# UNITED STATES PATENT AND TRADEMARK OFFICE

APPLICATION NO.	FILING DATE	FIRST NAMED INVENTOR	ATTORNEY DOCKET NO.	CONFIRMATION NO.
10/760,142	01/16/2004	Henry Graf	4002-3469	7214

<b>Office Action Summary</b>	<b>Application No.</b>	<b>Applicant(s)</b>	
	10/760,142	GRAF, HENRY	
	<b>Examiner</b>	<b>Art Unit</b>	
	Anitza M. San Miguel	3733

## **DETAILED ACTION**

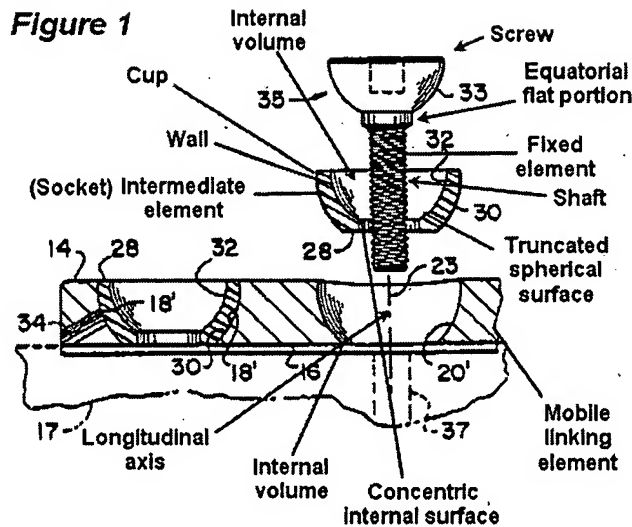
Park discloses an intervertebral linking device comprising: at least one fixed element (see Figure 1 below); at least one mobile linking element (see Figure 1 below); at least one intermediate element, wherein each intermediate element is received in an internal volume of a corresponding one of the at least one mobile linking element or of a corresponding one of the at least one fixed element, the intermediate element being deformable to be placed into the internal volume by impaction (see Figure 1 below and col. 3, lines 67-68 and col. 4, lines 1-5); and wherein the at least one fixed element or the at least one mobile linking element is received at least partially in an internal volume of the intermediate element having a mutual position of use with three degrees of freedom in rotation relative to the intermediate element while remaining linked in translation, and a mutual position of introduction in which the corresponding one of the at least one fixed element, or the corresponding one of the at least one mobile element, has three degrees of freedom in rotation and in translation relative to the intermediate element (see Figure 1 below). With regards to the three degrees of freedom in rotation relative to the intermediate element, the fixed element is capable of performing movement in three degrees of freedom. The fixed element may be capable of rotation in the x-y-z axis.

The intermediate element assumes the form of a cup (see Figure 1 below). The internal volume of the intermediate cup is bordered by a truncated spherical surface (col. 3, lines 10-13). The intermediate cup has a truncated spherical external surface,

which is concentric with the internal surface (see Figure 1 below). The internal and external surface defines a wall of the intermediate cup. The intermediate element is produced from polyethylene (col. 3, lines 67-68 and col. 4, lines 1-5).

Park further discloses the internal volume being at least part spherical having an internal diameter and an opening with a width smaller than said internal diameter, and wherein said intermediate element has an external diameter that is substantially the same as the internal diameter of said internal volume, such that when said intermediate element is inserted into said internal volume, said opening prevents said intermediate element from falling out of said internal volume (see Figure 1 below). The intermediate element (see Figure 1 below) has an internal volume having an internal diameter and an opening to said internal volume having a width less than said internal diameter, and said fixed element has a spherical head with an equatorial flat portion, said spherical head having a diameter between spherical surfaces that is substantially the same as said internal diameter, and said equatorial flat portion has a diameter that is substantially equal to said width of said opening (see Figure 1 below). The fixed element is a screw (first and second) having a shaft with a longitudinal axis, and said flat surfaces do not intersect said axis (see Figure 1 below). The linking member is separated from at least one of the bone by the at least one fixed element (see Figure 1 below).
